Access Compliance Report

Public Rights-of-Way

(Curb Ramps)

Intersection ID: 28277	Main Street: EASTON GREY LN	Cross Street: PEMSWOOD ST	Location: NW
ADA ID: EFCAE32A38D8	Ramp Type: BlendTrans2	Initial Pass/Fail: Fail	Overall Compliance: No
Severity Score: 10			
Codes/Mitigation Info/Possible Solution		Field Measurements/Component Compliance

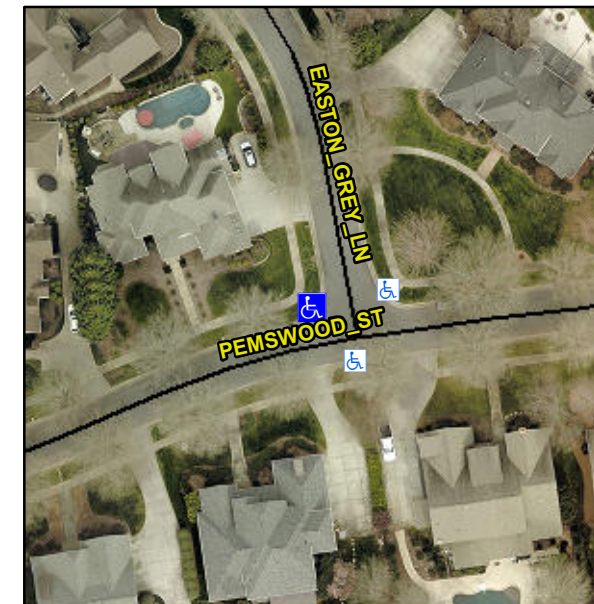
R304.5.1, R304.5.3

Compliance	Description	Data	Compliance	Description	Data
N/A	Ramp Length (in)	156.0	Yes	BlendTrans Slope (%)	3.3
No	Ramp Width (in)	39.0	No	BlendTrans XSlope (%)	2.2
N/A	Flare Type LT	N/A	N/A	Flare Type RT	N/A
N/A	Flare Slope LT (%)	N/A	N/A	Flare Slope RT (%)	N/A
N/A	Flare Traversable LT?	N/A	N/A	Flare Traversable RT?	N/A
N/A	Landing Length (in)	N/A	N/A	DWS Provided?	N/A
N/A	Landing Width (in)	N/A	N/A	DWS Contrast?	N/A
N/A	Landing Slope (%)	N/A	N/A	DWS Length (in)	N/A
N/A	Landing X Slope (%)	N/A	N/A	DWS Full Width?	N/A
N/A	Landing Curb? (Y/N)	N/A	N/A	DWS Offset (in)	N/A
N/A	Shared Landing?	N/A			
N/A	Gutter Ponding?	N/A	N/A	Gutter Slope (%)	N/A
N/A	Gutter Lip Ht (in)	N/A	N/A	Gutter X Slope (%)	N/A
N/A	Painted X Walk1?	No	N/A	Painted X Walk2?	No
	X Walk 1 Direction	To S		X Walk 2 Direction	To E
	X Walk 1 Width (in)	N/A		X Walk 2 Width (in)	N/A
	X Walk 1 Slope (%)	2.3		X Walk 2 Slope (%)	0.8
	X Walk 1 X Slope (%)	1.4		X Walk 2 X Slope (%)	2.6

N/A	Ramp inside XWalk1?	N/A	N/A	Ramp inside XWalk2?	N/A
	Road Slope (%)	2.6		Clear Space?	N/A
	Road X Slope (%)	0.1	N/A	Clear Space to XWalk (in)	N/A
N/A	Any Obstructions?	N/A	N/A	Storm Grate/Utility Hazard?	N/A
	Obstruction Type			Storm Grate/Utility Type	
		N/A			N/A
			Yes	Surface Condition? (G/P)	Good
			N/A	Curb Slope (%)	1.1

Remove & Replace Curb Ramp With Two New Directional Ramps or Equivalent.
